Sydenham to Bankstown Metro: Key issues and opportunities

December 2017

Endorsed by Council 28 November 2017

The City of Canterbury Bankstown (Council) provides comment on the Metro Southwest EIS to highlight the significant city shaping opportunities that would be missed if the current plan was constructed as proposed.

Figure 1: TfNSW EIS Concept Plan for Bankstown Station; annotated by Canterbury-Bankstown Council

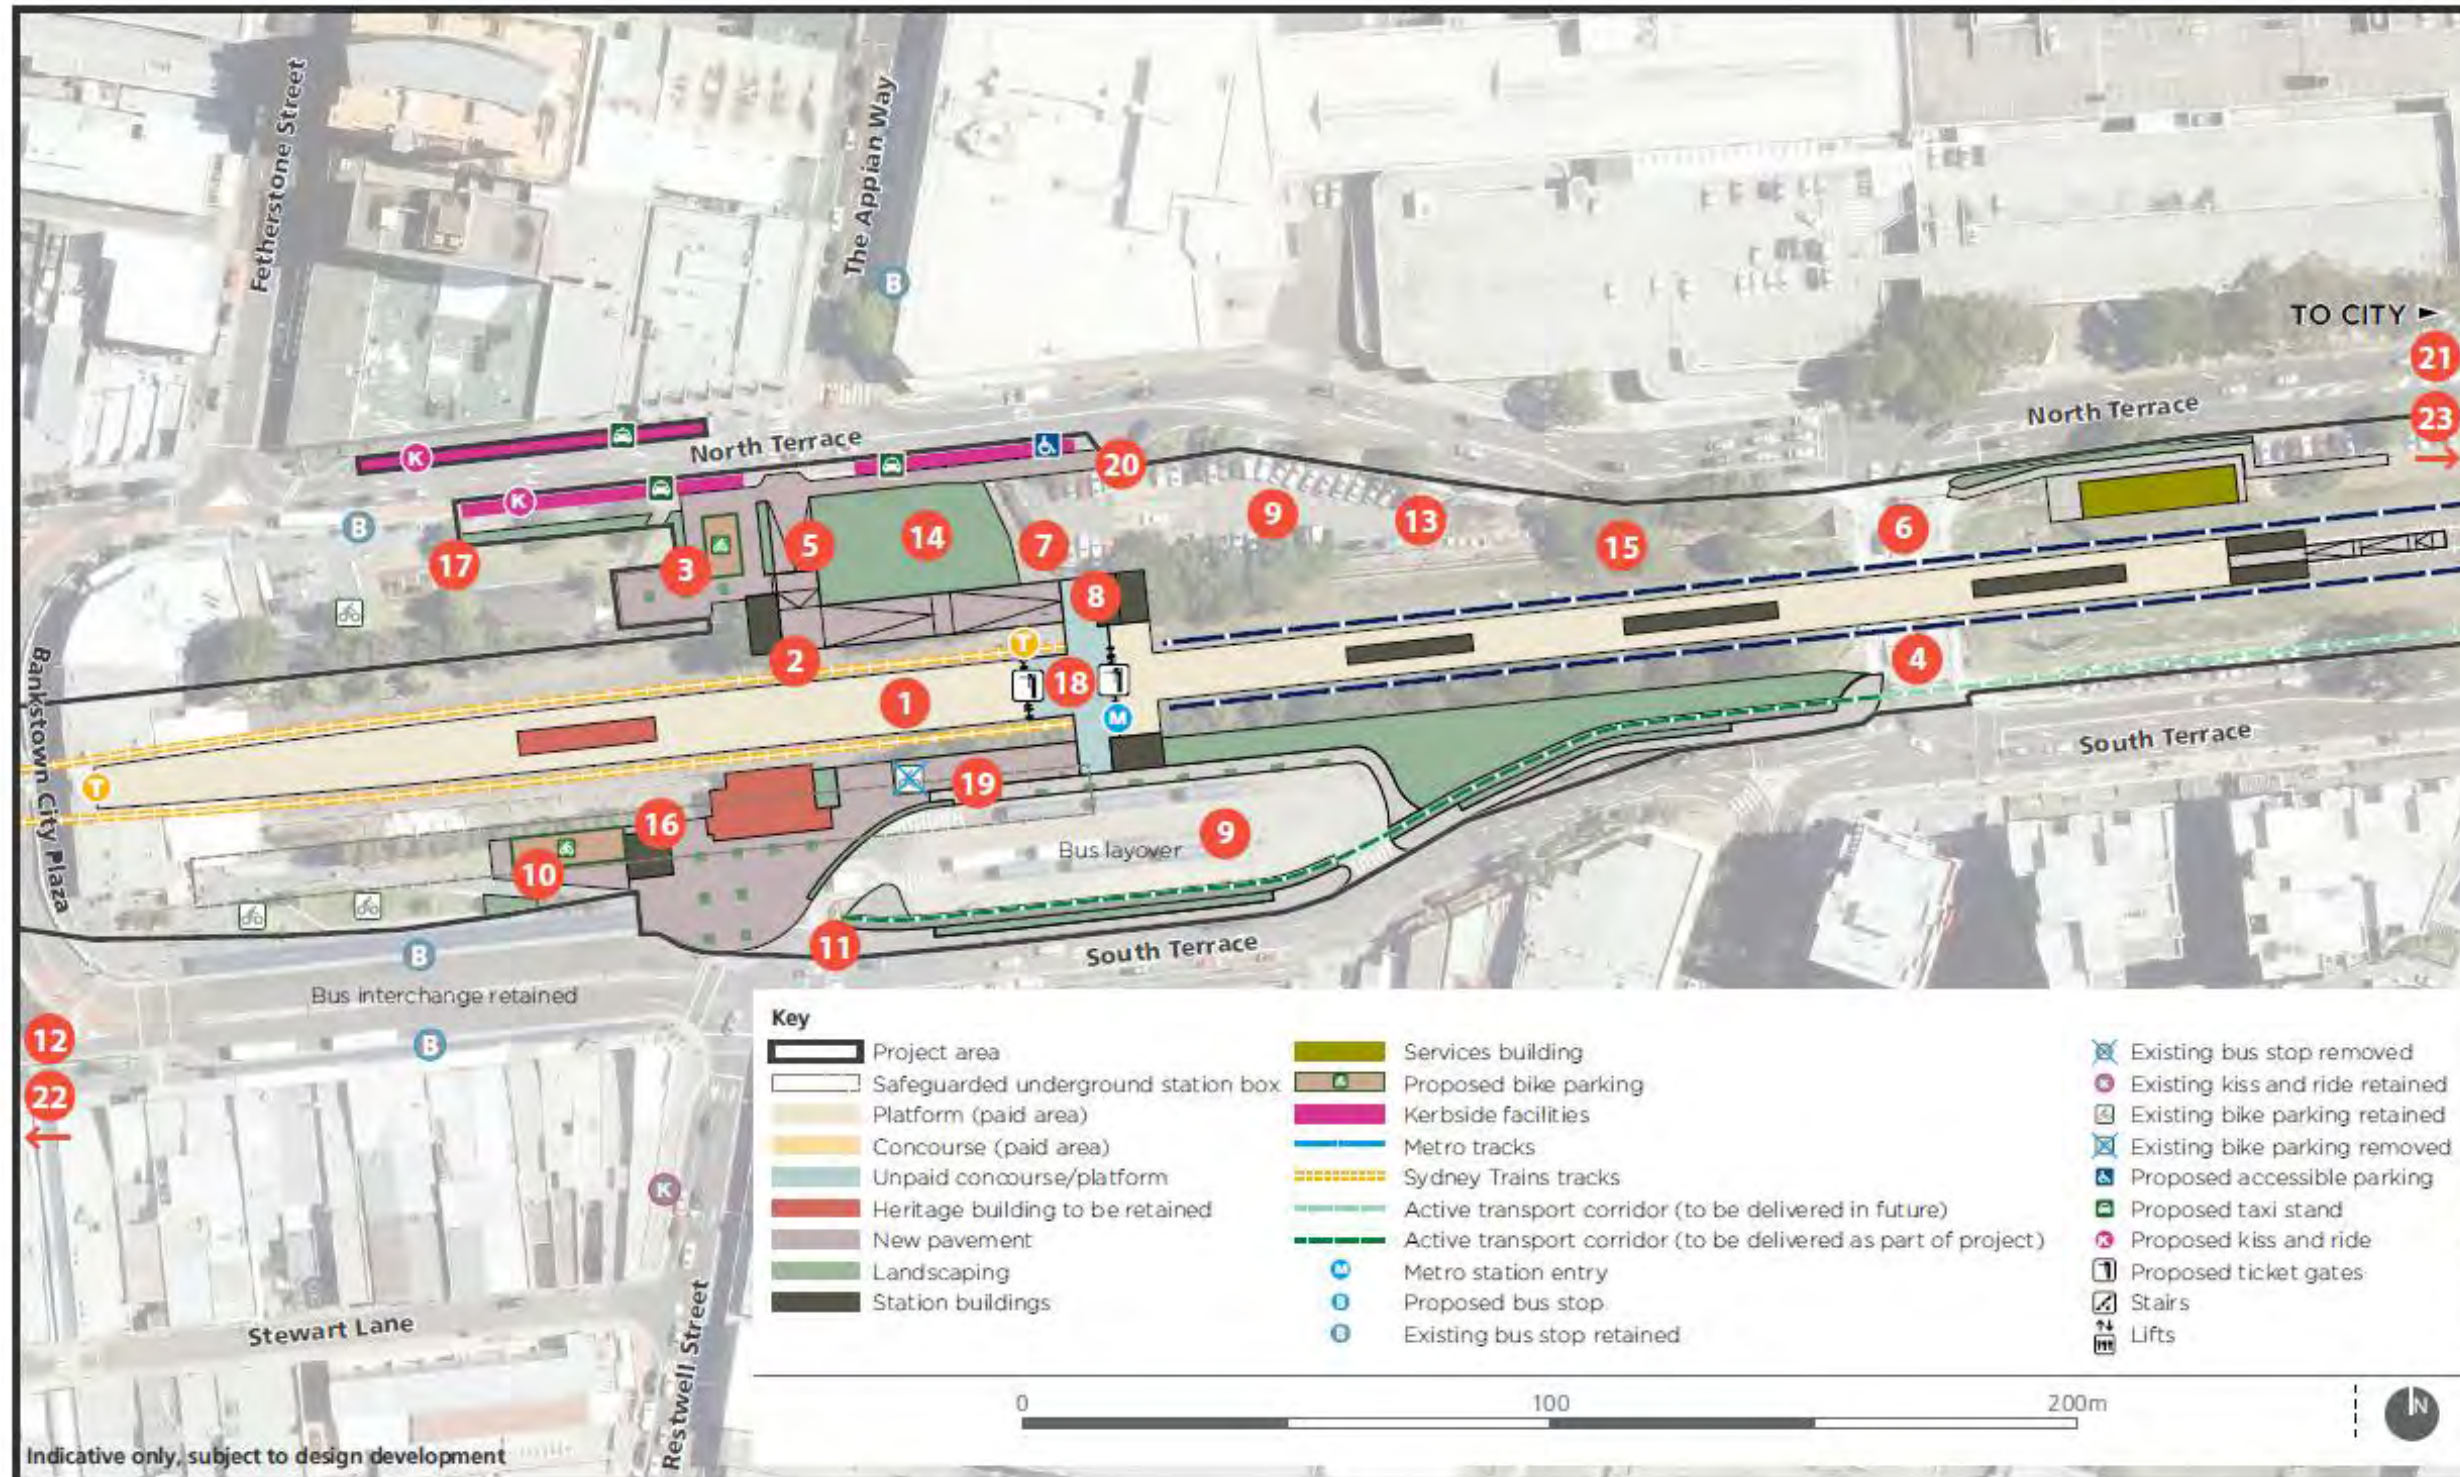
22	More information required on impact on Bankstown Arts Centre	Detailed information required for potential work on west side of station adjacent to Bankstown Arts Centre	<ul style="list-style-type: none"> Trees are retained with no damage 	<ul style="list-style-type: none"> Trees are retained with no damage 	Table 17.2	
23	Additional overpasses	Walkability, connectivity and permeability should be increased between Bankstown and Punchbowl Stations. The existing rail line has no crossings between Stacey Street and Punchbowl Road (1,600m). Two additional overpasses should be provided between Stacey Street and Punchbowl Road. Preferred locations are in line with Scott Street and near the corner of Stansfield Avenue and Wattle Road or through 150 Wattle Road (requires easement through private land or property acquisition).	<ul style="list-style-type: none"> An additional crossing every 400m between Stacey Street and Punchbowl Road 	<ul style="list-style-type: none"> Two additional overpasses between Stacey Street and Punchbowl Road. Preferred locations are in line with Scott Street and near the corner of Stansfield Avenue and Wattle Road or through 150 Wattle Road (requires easement through private land or property acquisition). 		13 (2)

Figure 2: TfNSW EIS Concept Plan for Punchbowl Station; annotated by Canterbury-Bankstown Council

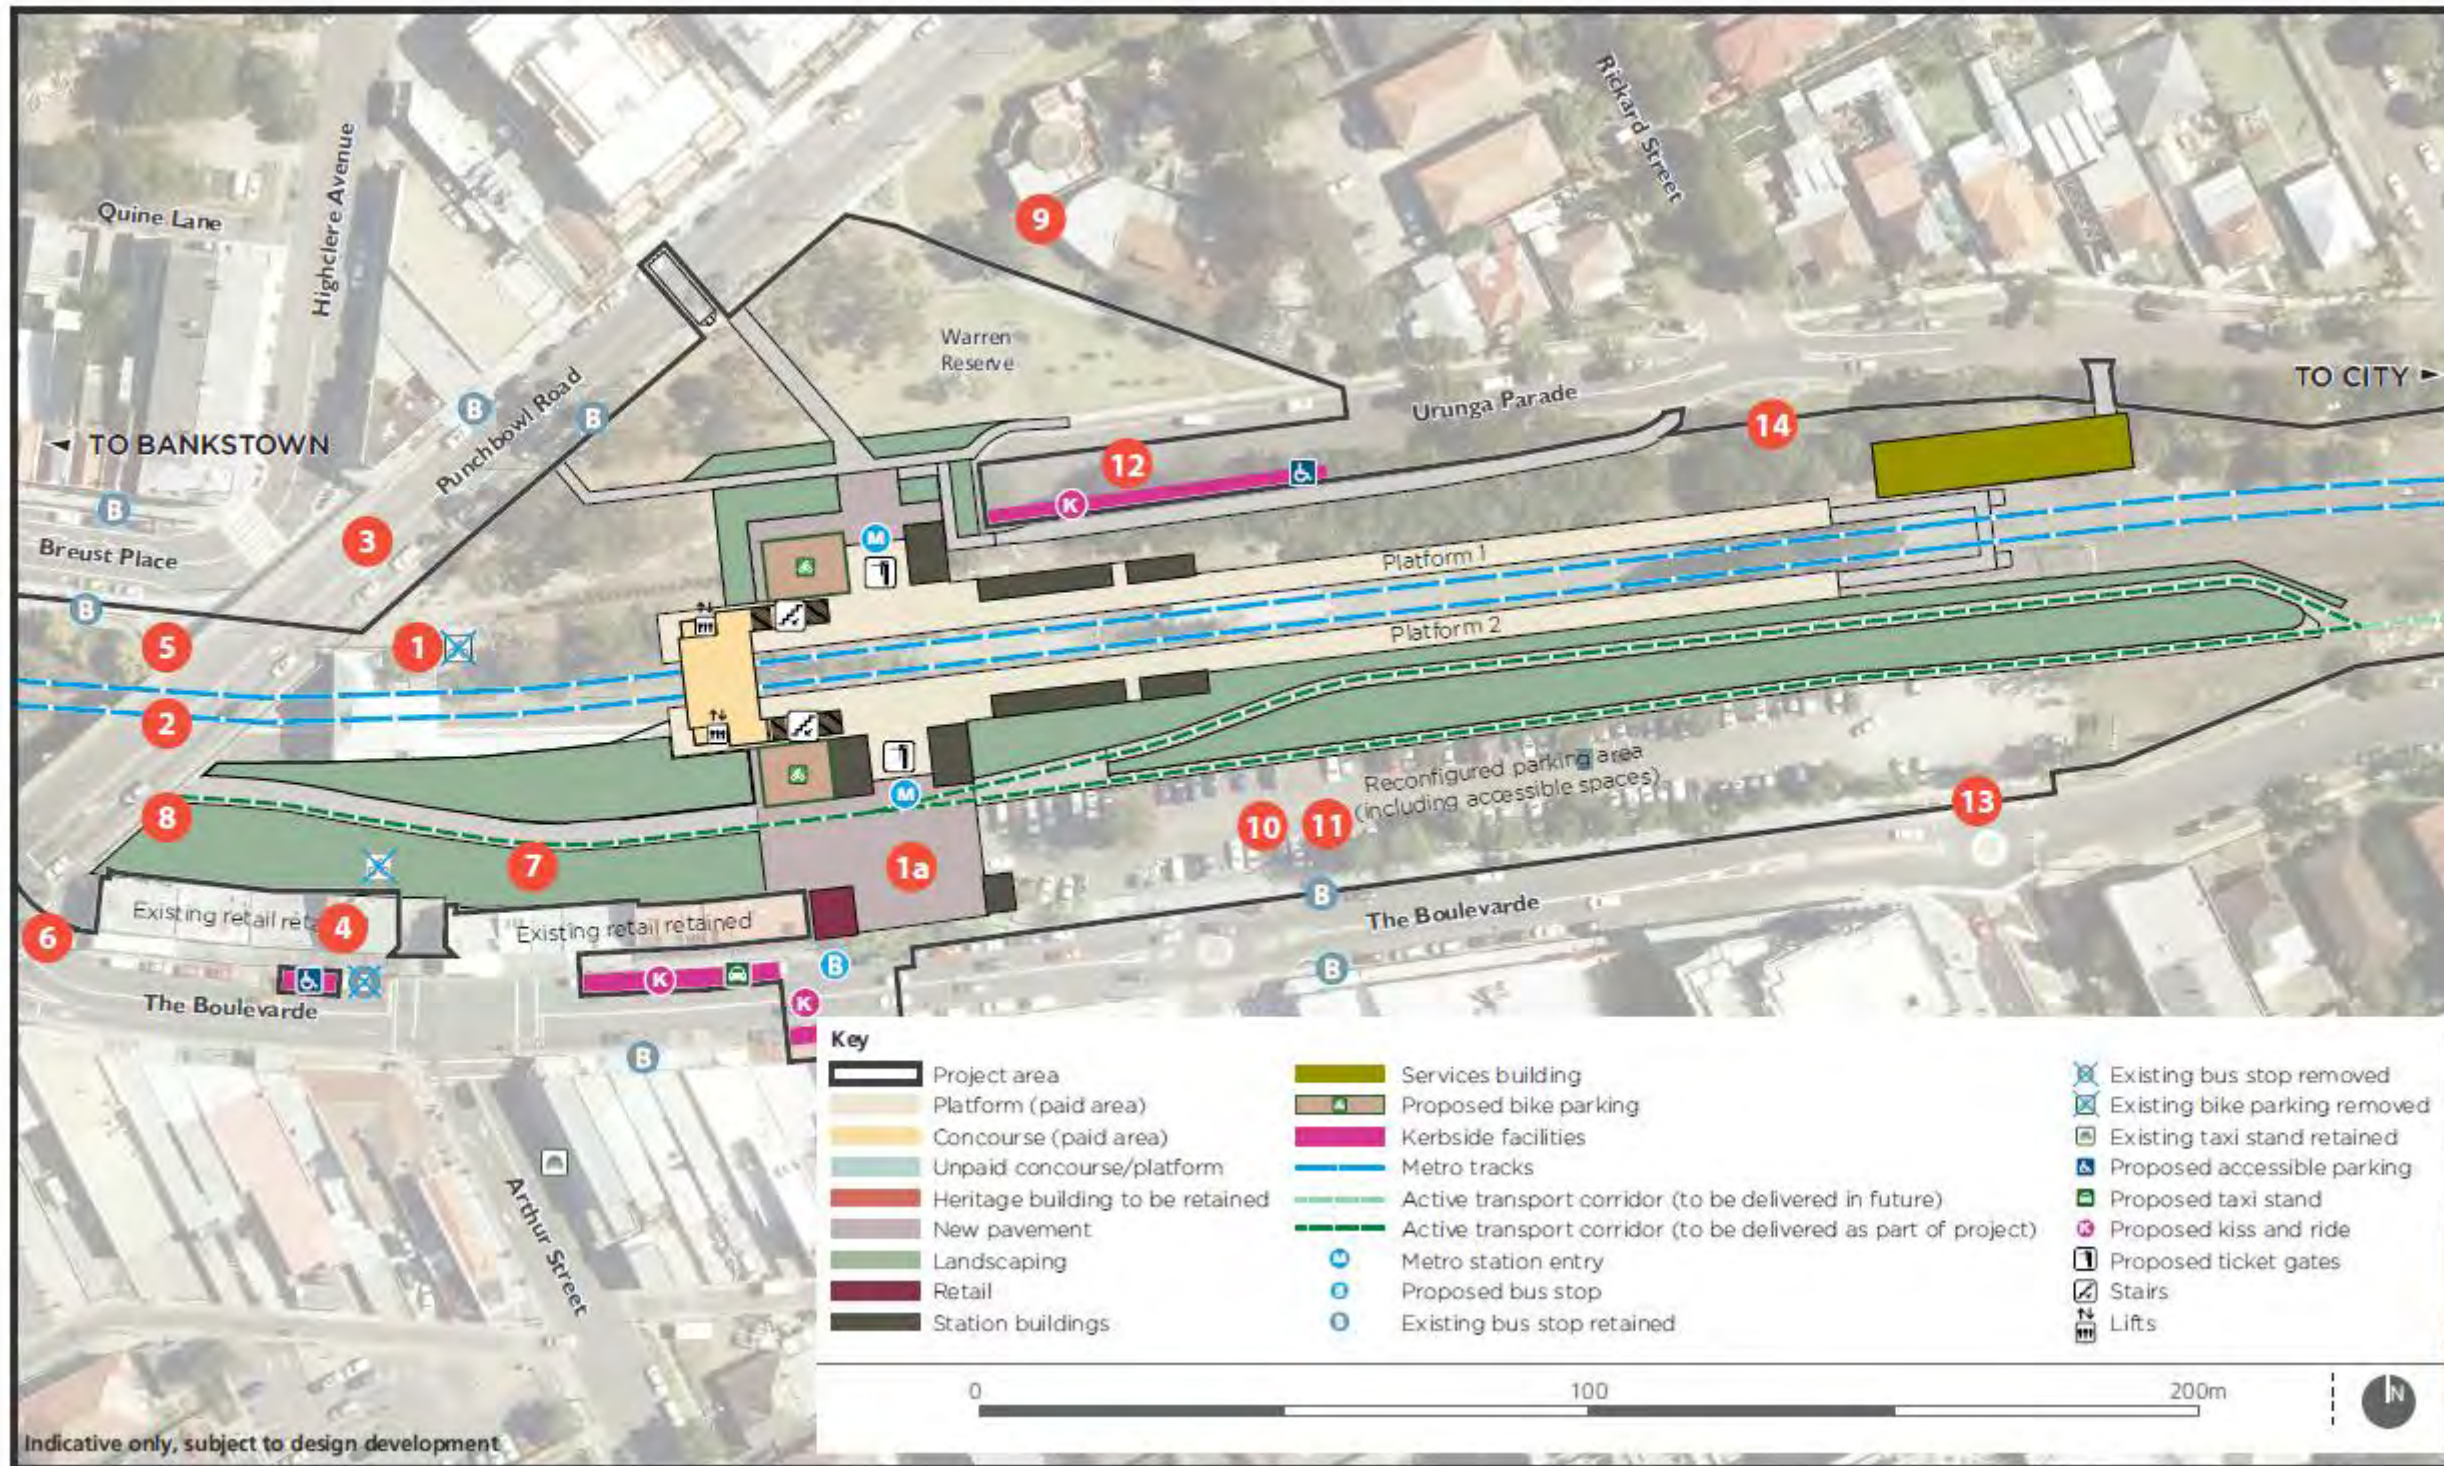
14	Additional overpasses	<p>Walkability, connectivity and permeability should be increased between Punchbowl Station and King Georges Road. The existing rail line has no crossings between Punchbowl Station and King Georges Road (1,300m). An additional overpass should be provided. Preferred location is in line with Robinson Street.</p>	<ul style="list-style-type: none"> In addition to the two new overpasses suggested as part of Punchbowl and Wiley Park station provide a crossing between Punchbowl Station and King Georges Road. Preferred location is in line with Robinson Street. 	<ul style="list-style-type: none"> An additional overpass should be provided. Preferred location is in line with Robinson Street. 		13 (2)
